Subject: 703-723 W Algonquin Rd, PC #17-013 Round 1 Final Plat

PLAN COMMISSION PC #17-013
Hamilton Partners – Arlington Heights Subdivision
703-723 W. Algonquin Road
PUD, Prelim/Final Plat of Subdivision
Round 5

ROUND 1 – FINAL PLAT

Project: 703-723 W. Algonquin Rd
Hamilton Partners Distribution Facility

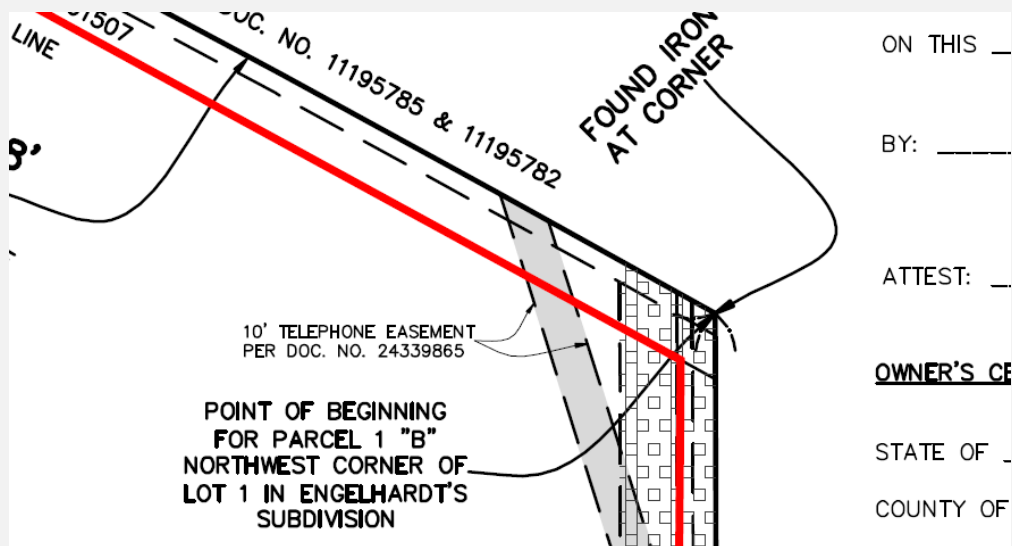
5. The dark line on the Plat of Subdivision separating Phase I and Phase II (the northern portion and southern portion of the property) is unnecessary. Please show this line as a dashed line since it represents the boundary of a 10' gas easement (that is being vacated).
6. The hatching of the sanitary sewer easement in the legend is inverted. Please adjust the hatching to match the direction of the hatching as shown on the Plat.
7. The front building setback line should extend parallel to the 46.73' segment in the northwest corner of the site.
8. Where the front and side yard building setback lines cross, the setback lines should not continue passed each other to the edge of the property line. Please adjust all crossing setback lines as per the example below in red:
